AusNet Services 2026 - 2031 Regulatory Proposal

REVIEW OF ASPECTS OF PROPOSED NETWORK RELATED EXPENDITURE AND CER

Report prepared for:
**AUSTRALIAN ENERGY
REGULATOR (AER)**
August 2025

Figure 3.5: Historical and forecast replacement volumes for HV switches and circuit breakers

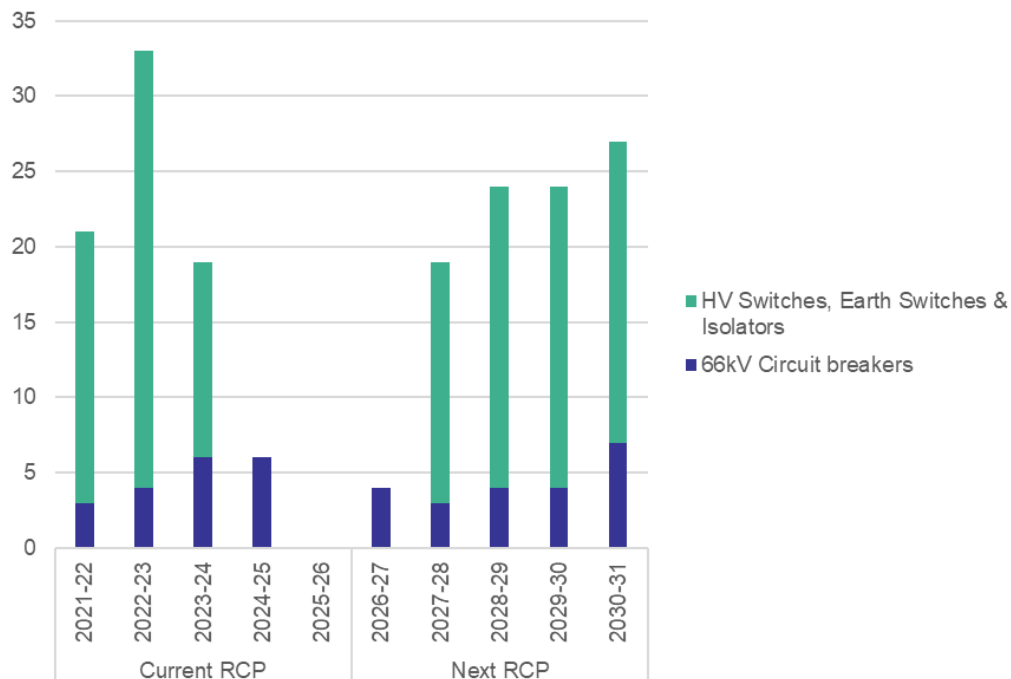
275. We asked AusNet to provide historical replacement levels for HV switches and circuit breakers, which is shown in Figure 3.5. There is a marked difference in the presentation of the magnitude and timing of the historical volumes for the relevant categories in Figure 3.4 and Figure 3.5. Some of the differences may be explained by:

- Construction versus commissioning times, which may impact the reporting year. and
- Inclusion of a proportion of other voltage switches, or other assets.

Figure 3.7: Failure events versus age of control box

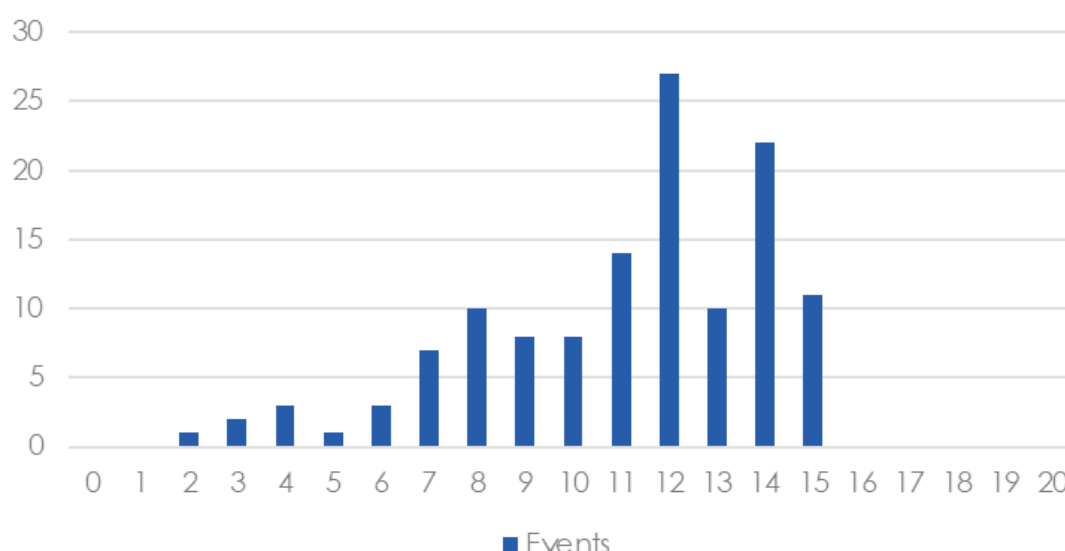
328. We show the distribution of failure events recorded by AusNet by age in Figure 3.7. The figure shows that the failures have occurred between 2 and 15 years.

Figure 3.9: Curve fit of failure data

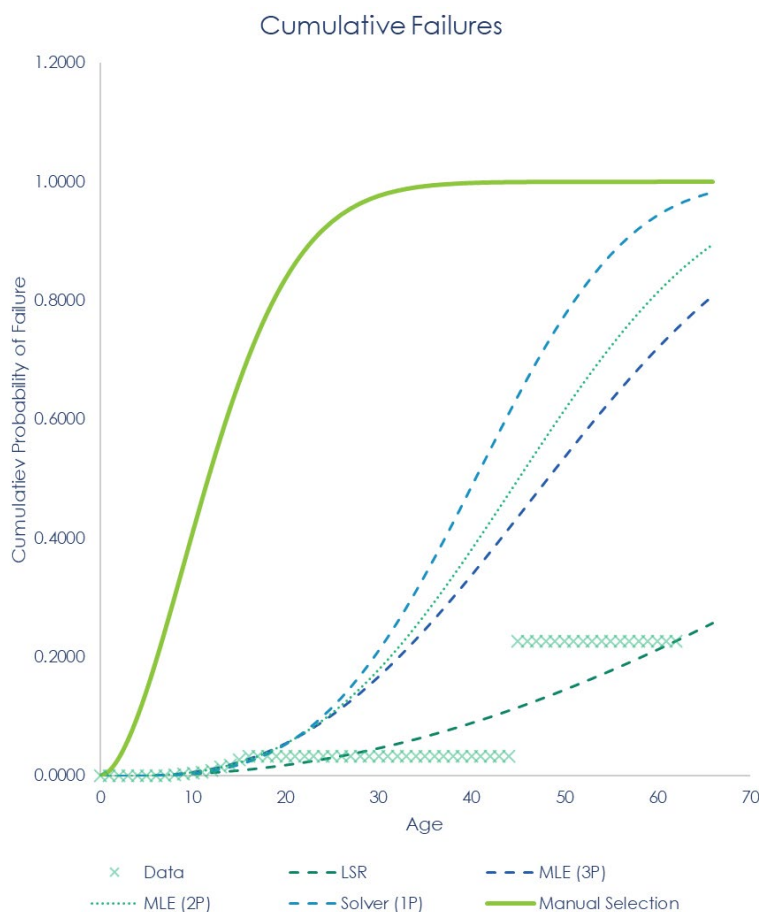
334. As shown in Figure 3.9, the adopted Weibull parameters result in a much steeper failure rate than the failure data would indicate. The Weibull predictions indicate 980 failures pa, which compares with the historical failures of 26 p.a.

Figure 3.12: Comparison of historical and forecast pole intervention volume

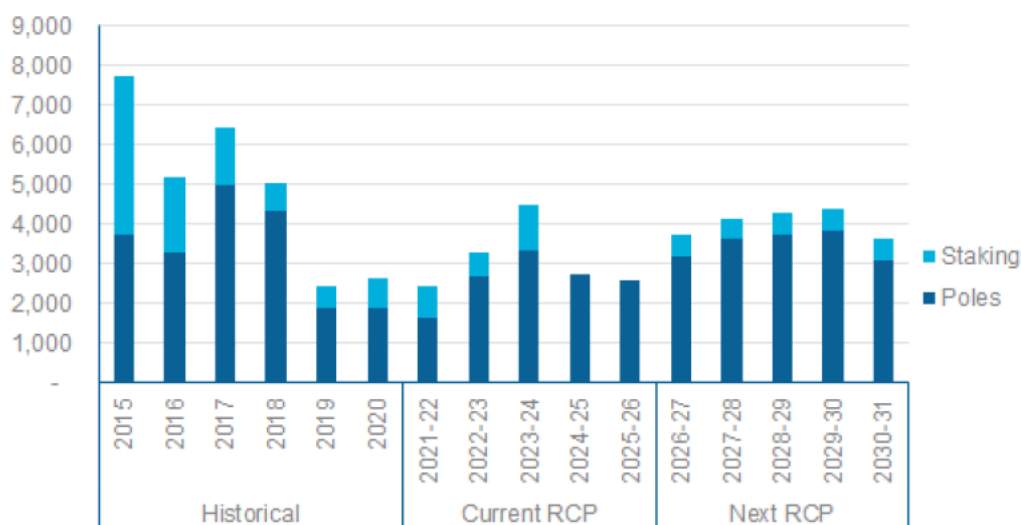
365. Figure 3.12 shows the total pole interventions recorded in the RIN, which increase from 15,570 to 20,211 from the current RCP to the next RCP. The intervention profile increases from 2021-22 for two years before reducing for 2024-25. A step increase is observed from 2026-27 which we understand is primarily due to the introduction of additional programs, such as resilience.
366. The reason for the increase observed in 2023-24 is not explained by AusNet.
367. When the resilience program is included, including pole hardening, the proposed pole interventions are materially higher than the 10% increase from the current period.

Figure 3.13: Calculated staking rate

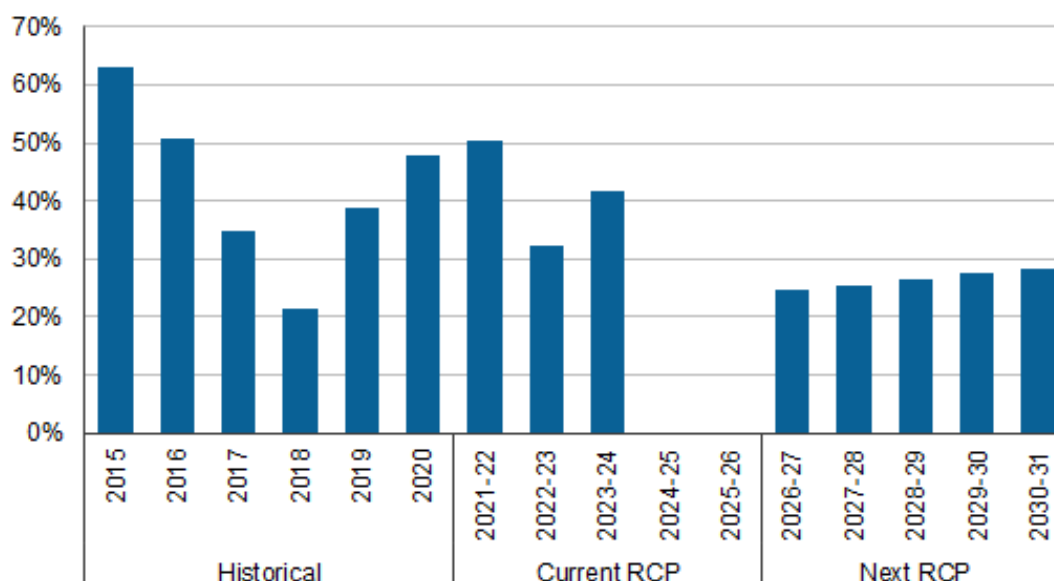
398. Figure 3.13 shows the staking rate as a percentage of total wood poles replaced as recorded in the RIN. This will include poles replaced in response to other drivers, however we expect the volumes associated with the pole replacement program to dominate.
399. We observe historical staking rates⁷¹ averaging around 40% prior to 2024-25. For the next RCP, the staking rate at a total pole level⁷² averages 26%. Whilst this average exceeds the wood pole staking rate calculated for the pole intervention program alone, both values are well below the historical staking rate and industry practices. Based on this raw analysis, the forecast reinforcement rates are much lower than AusNet has historically undertaken.

Figure 4.7: Optimum timing – Eastern Cranbourne 66kV loop augmentation (\$m2024)

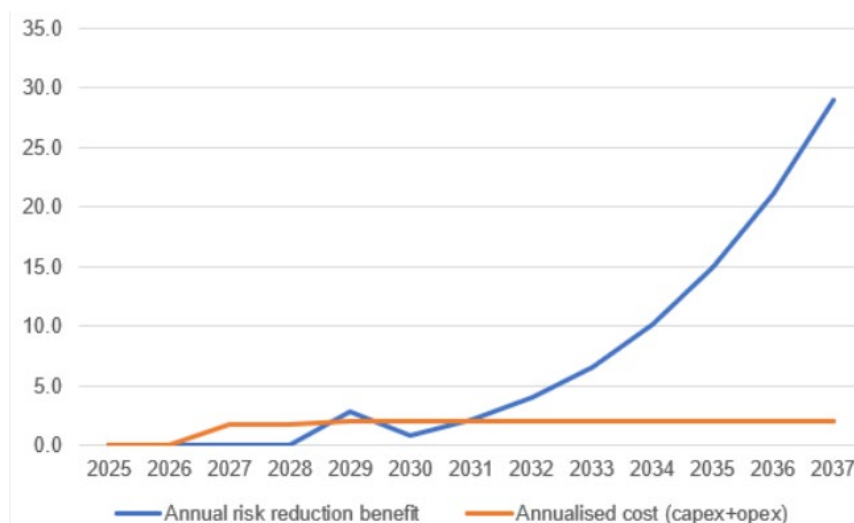
729. Whilst AusNet identifies the optimum timing for its proposed new CBTS-OFR 66kV line as 2029, its CBA model shows that the advent of the separately proposed PSH zone substation delays the optimum timing until 2031, as shown in Figure 4.7. Therefore, subject to PSH substation proceeding as planned, the new CBTS-OFR line could be deferred to 2031 or possibly beyond depending on actual demand growth.

Figure 4.11: Optimum timing derivation – proposed new Pakenham South zone substation

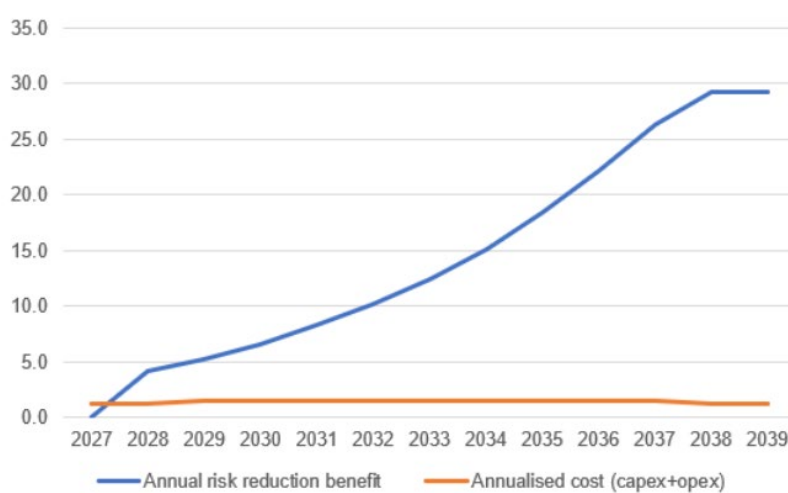
791. AusNet's cost-benefit model identifies the economic timing of the proposed PSH substation as FY2028, as shown in Figure 4.11. The extent of EUE growth due to the breach of N-1 and later N ratings at CLN lead to the optimal timing early in the next RCP.
792. Using an alternative 'low' demand forecast of 100% 50PoE, the monetised EUE is reduced from \$8.9 million in 2029¹⁸⁶ to \$3.4 million but given the annualised cost of the proposed work is \$1.5 million, the optimal timing remains within the next RCP, all other things being equal.

Figure 4.12: Estimated value of EUE (primarily driven by expected overload of KLO)

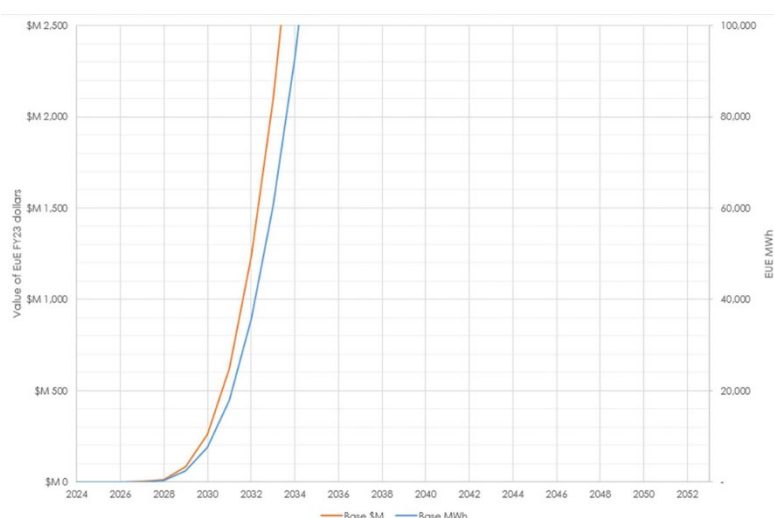
799. KLO's demand is expected to exceed the N capacity for 20% or more of the year by 2031.¹⁸⁸ If this demand growth is realised, it generates a very high monetised EUE as shown in Figure 4.12. Even allowing for some emergency overload capacity, the EUE would be very high.

801. In our view, this provides sufficient evidence to support some form of intervention within the next decade.

Figure 5.10: AusNet's forecast EUE due to demand growth from electrification (MWh pa)

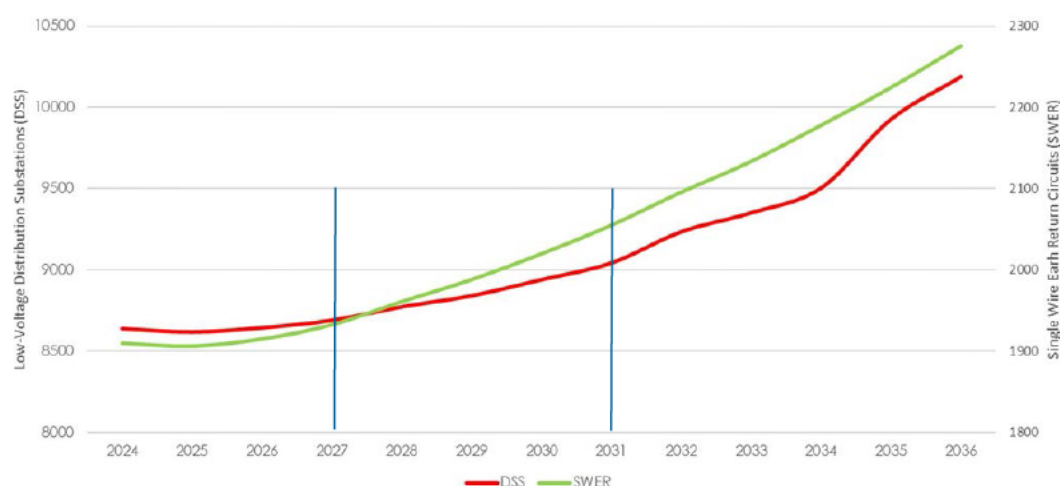
927. Our interpretation is that the unserved energy in 2024 and 2025 from overloaded DSS, which is the primary driver of AusNet's proposed program, is 12.8 MWh and 14.0 MWh respectively, which is a fraction of the 8,500 MWh or more shown in Figure 5.10. It also shows a declining trend in substation outages but a recently increasing trend in the energy lost per tripped DSS.

928. AusNet highlights in its response that in the previous and current RCP it has been investing to reduce the number of outages due to overload and has been quite successful in bringing down the number of DSS 'failures', as its data shows.
929. This data undermines the credibility of the information in Figure 5.10 and AusNet's analysis as a whole as the information that AusNet provided in Table 5.6 above is entirely inconsistent with the modelled levels of unserved energy that AusNet has based its proposed LV augmentation program on. The information that AusNet has now provided not only indicates a small level of unserved energy now but also suggests that the impact of electrification that AusNet has relied on for its business case, is significantly overstated.

Figure 5.13: EMCa assessment of the cumulative discounted net benefit of DSO - \$m, real 2024

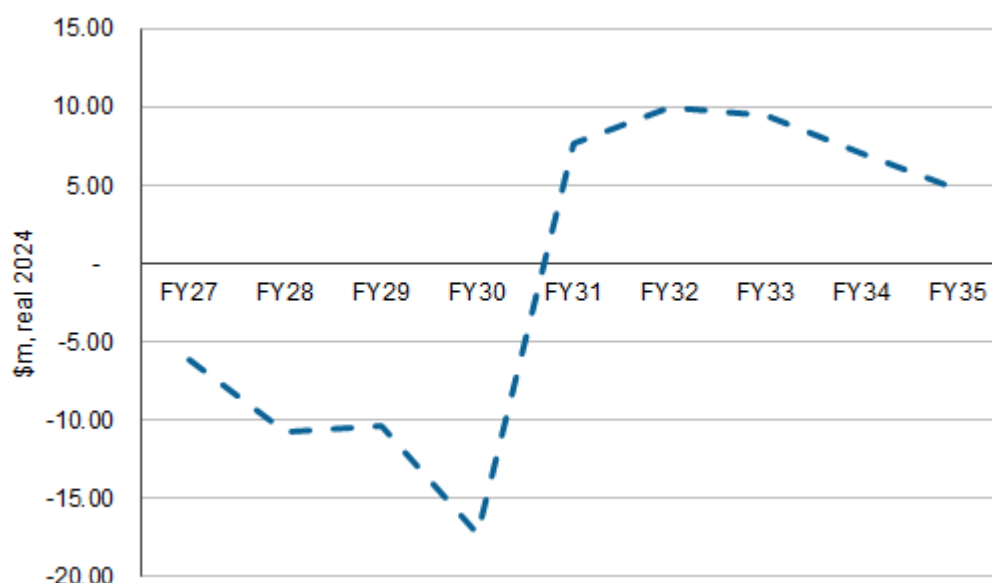
974. In Figure 5.13 we show the cumulative 'earning' of the eventual NPV of \$4.8m, that AusNet derives. This shows what we consider to be a highly implausible trend in which the proposed investment would have a positive NPV as soon 2031, but with ongoing costs from that time not offset by any material further benefits.
